ITEM 6.15:	COMMITTEE OF ADJUSTMENT REPORT MINOR VARIANCE APPLICATION A229/22 85 Rivermill Cr Maple
-------------------	--

**COMMITTEE OF ADJUSTMENT REPORT
MINOR VARIANCE APPLICATION
A229/22
85 Rivermill Cr Maple**

PROJECT
PROPOSED UPPER FLOOR REAR DECK
85 RIVERMILL CRES.
VAUGHAN, ONTARIO

SCHEDULE A: DRAWINGS & PLANS

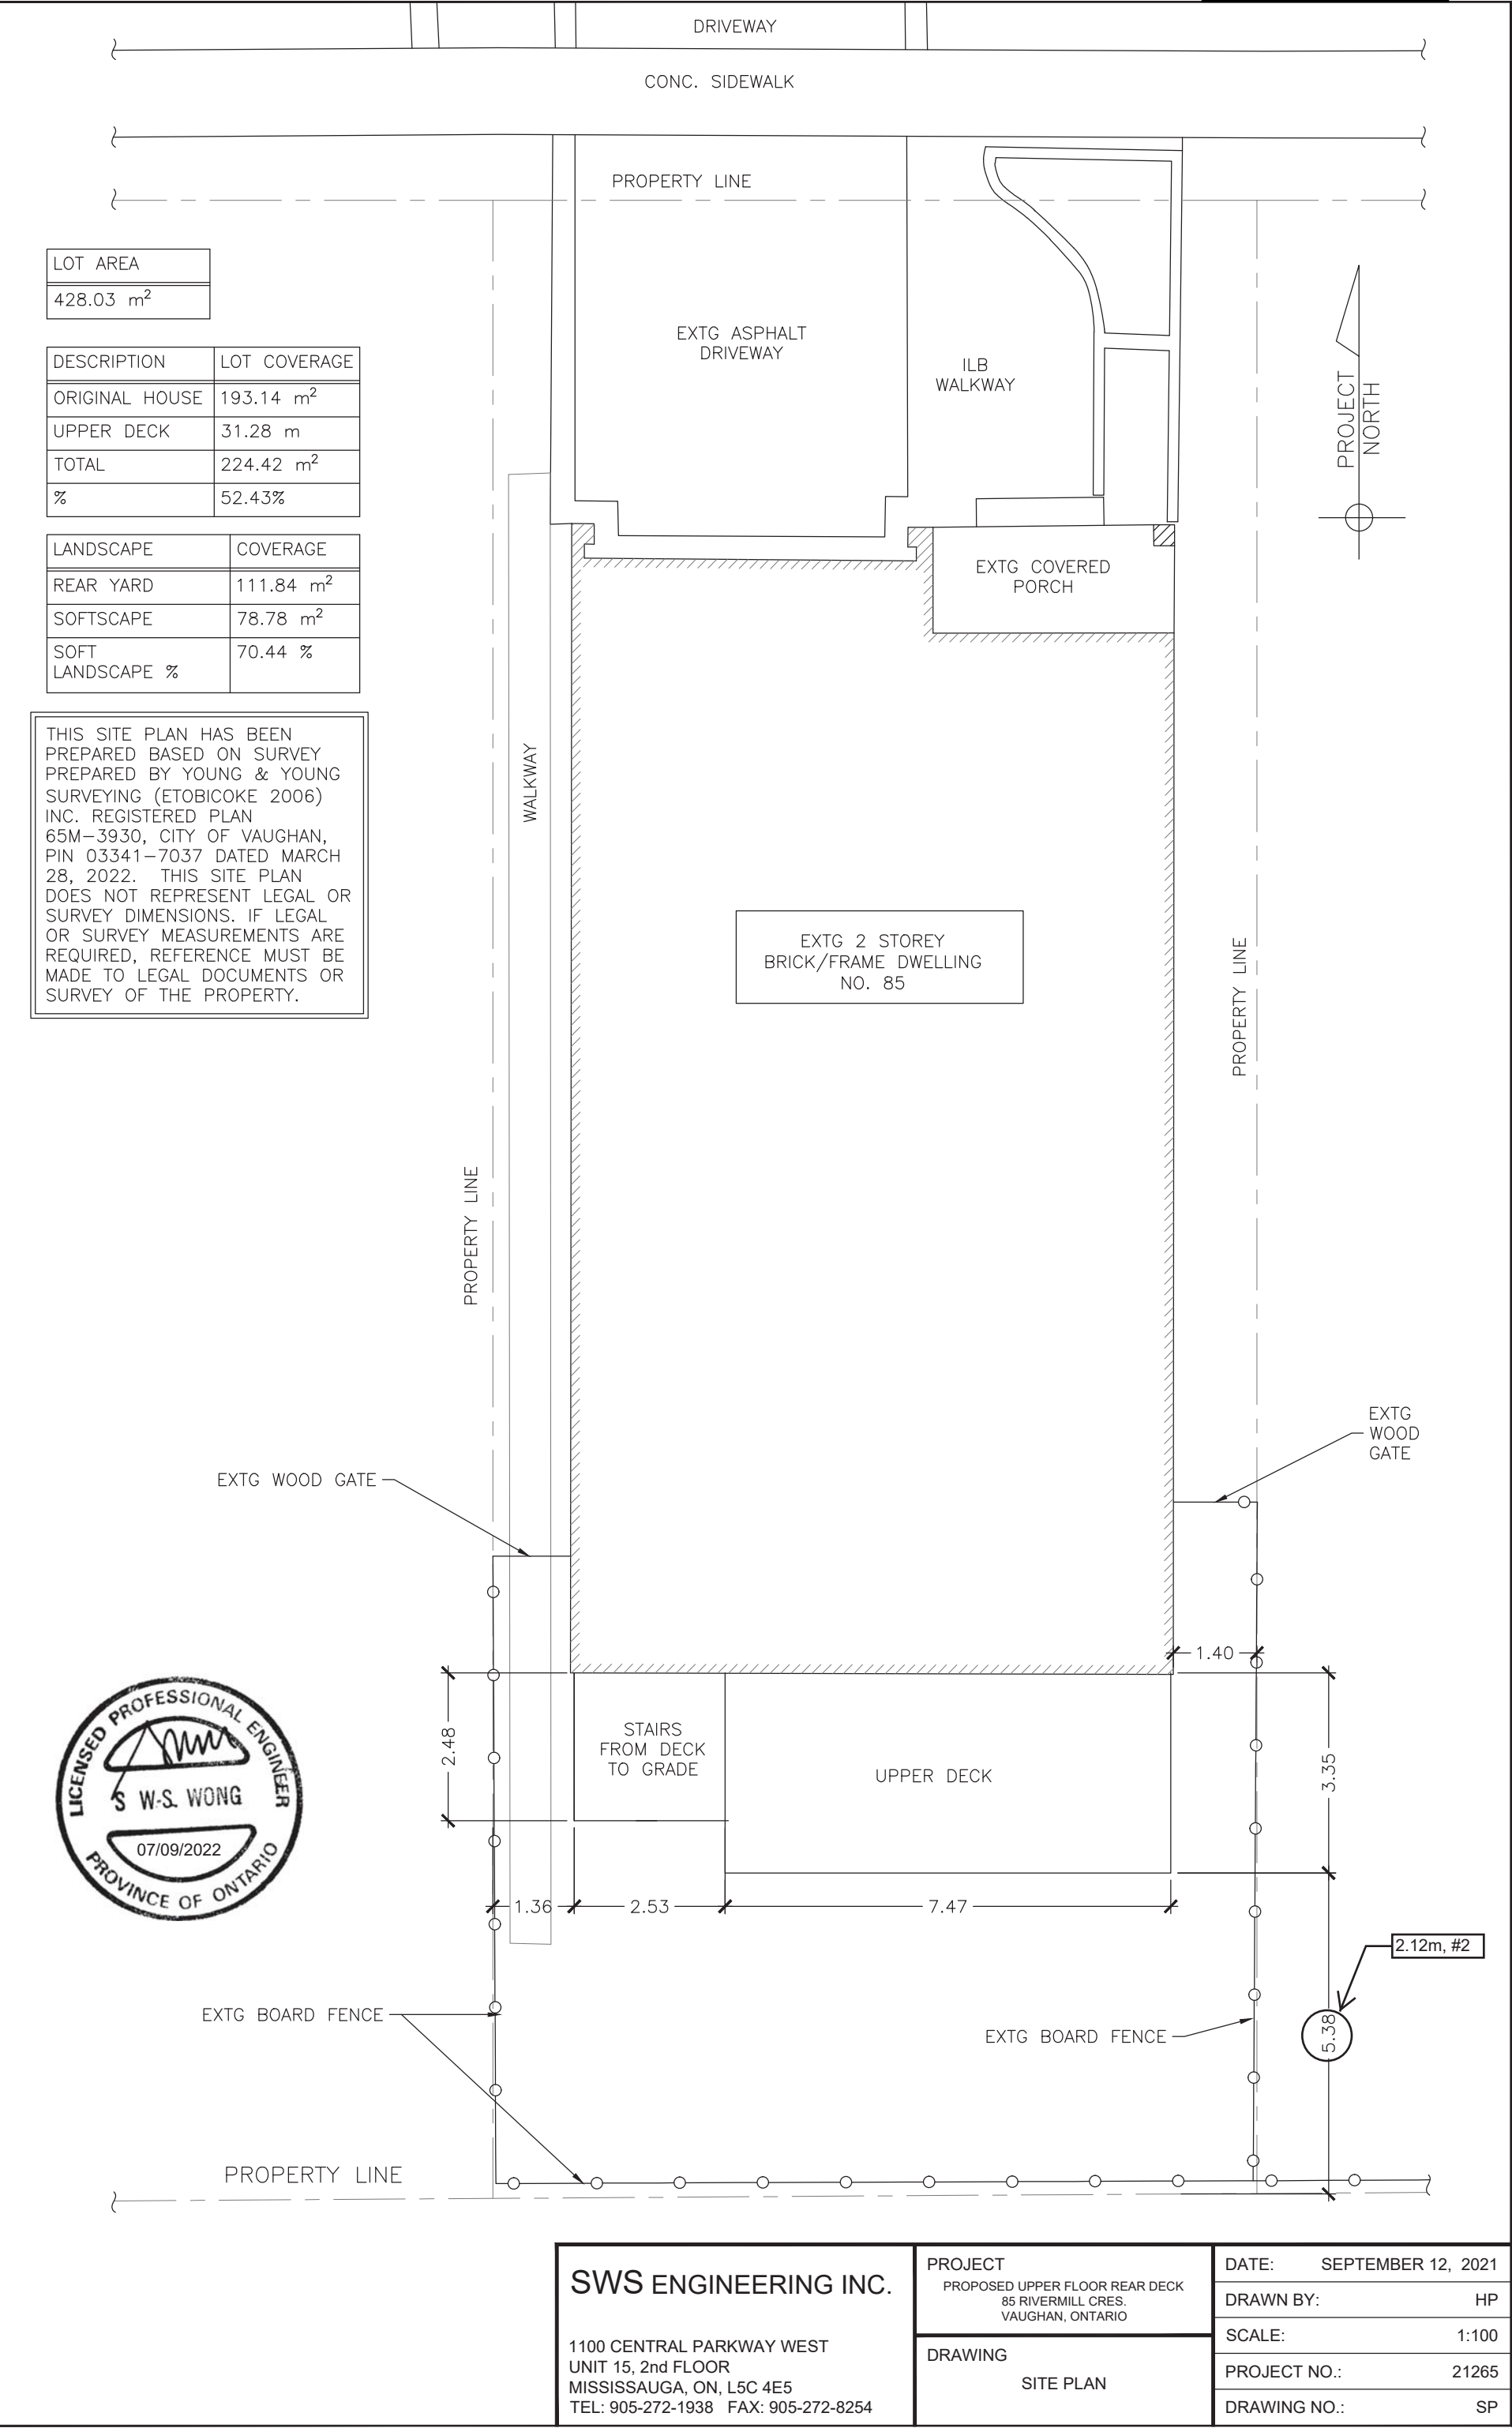
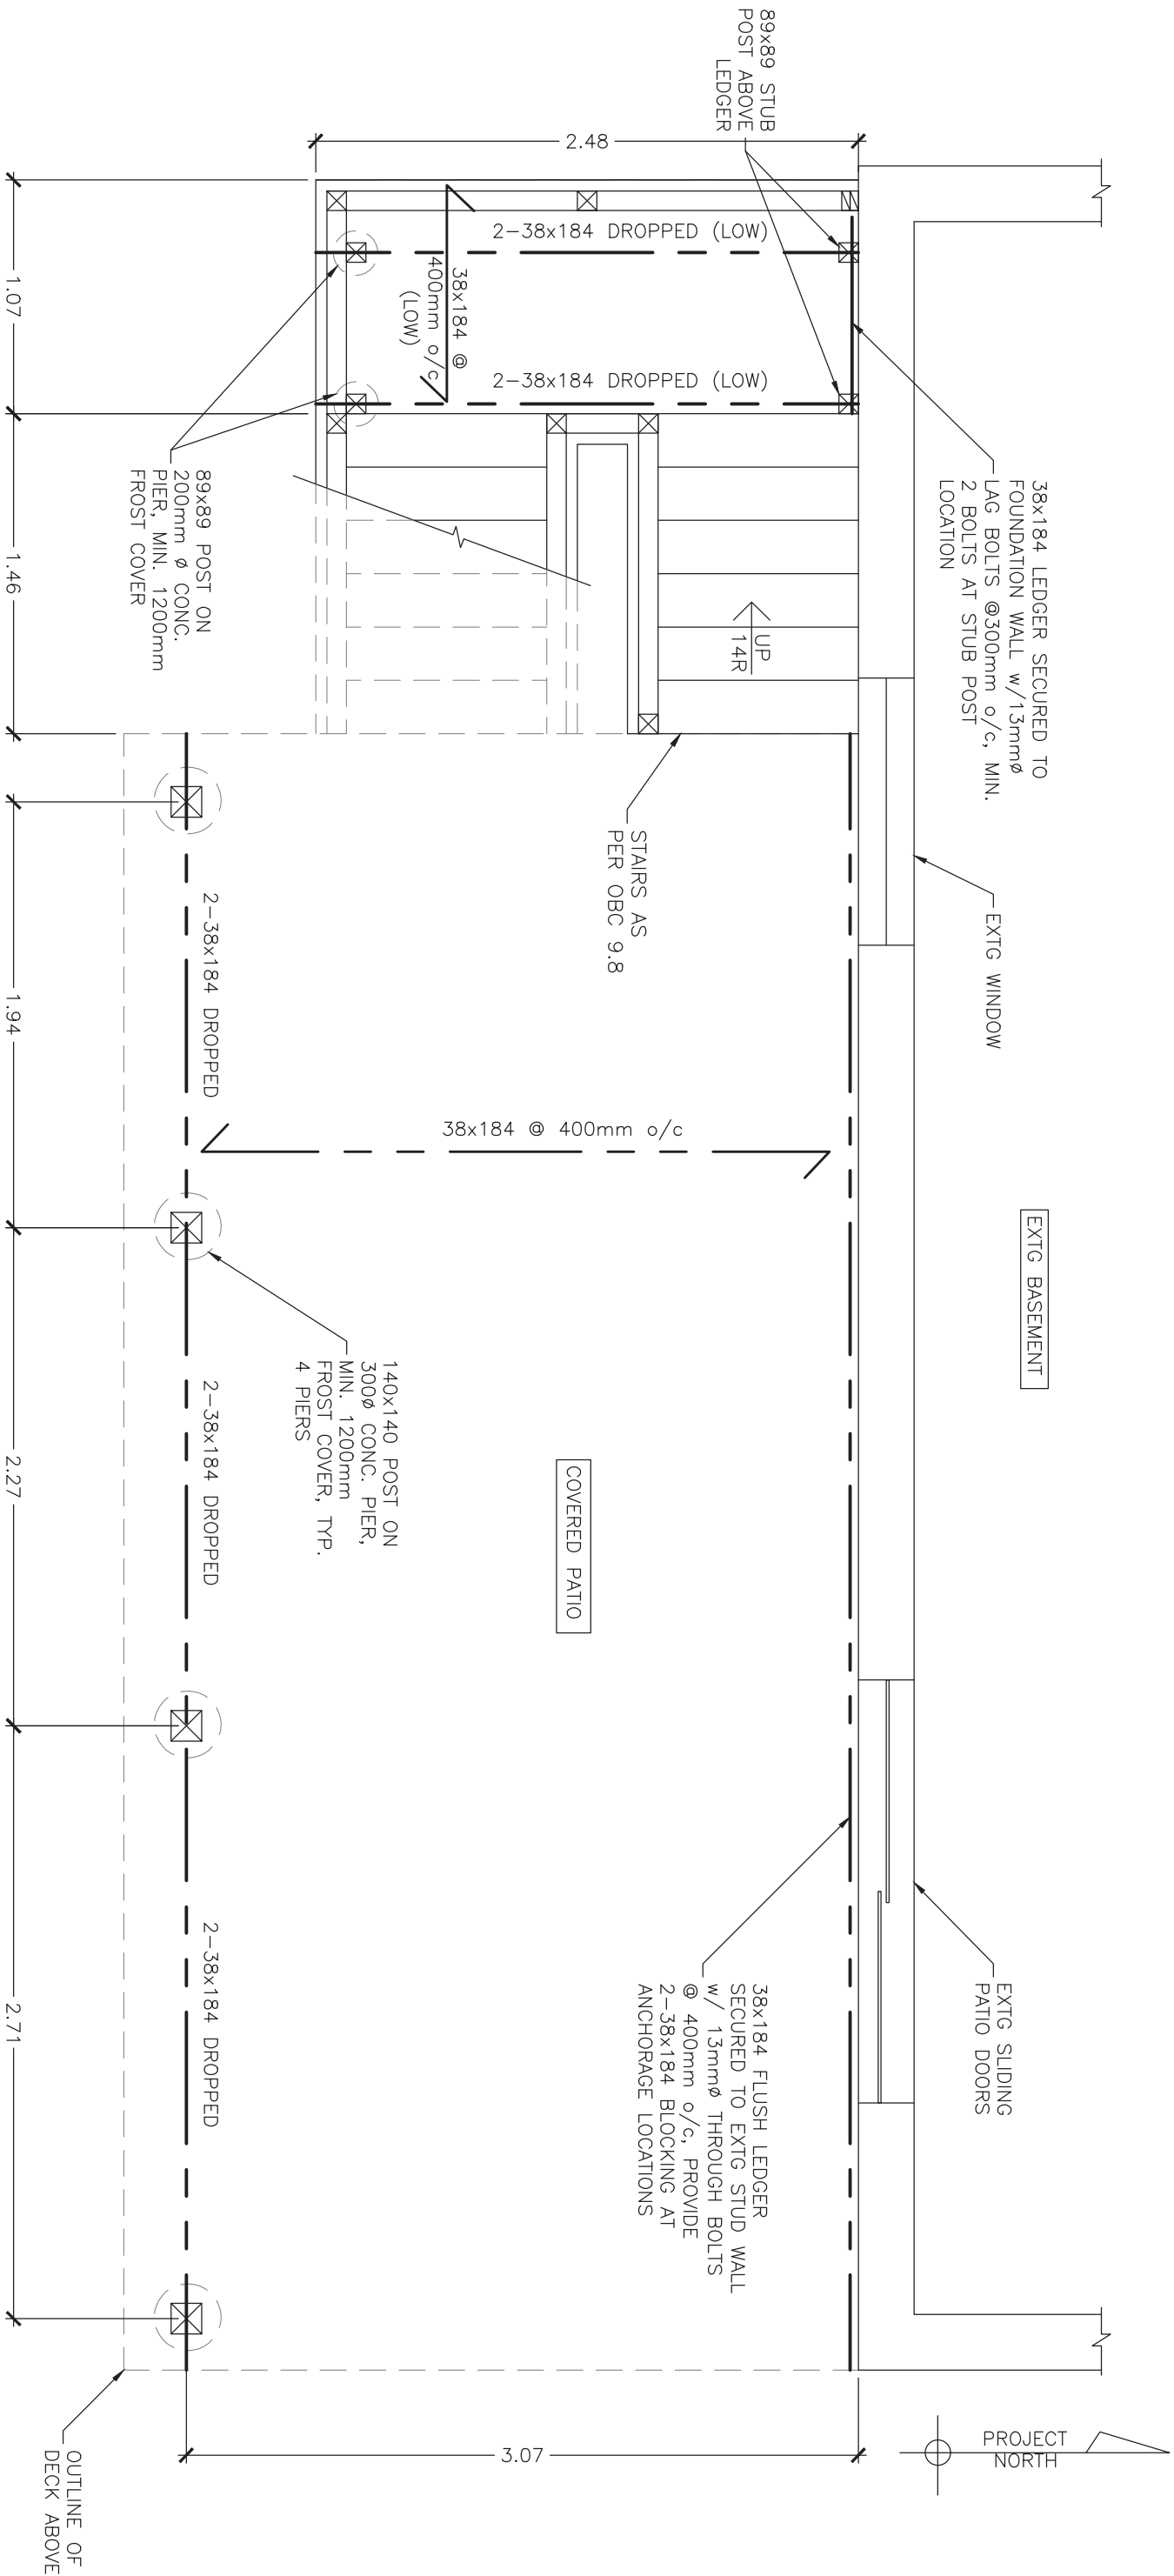
The Development Planning Department has no objection to Variance 1, as the 2.12 m maximum encroachment into the required rear yard for the uncovered deck will not pose a significant visual impact to nor impact the function of the abutting uses, maintains an appropriate area for access, drainage, and vegetated amenity space, and will not impact the abutting properties.

The Development Planning Department recommends approval of the application.
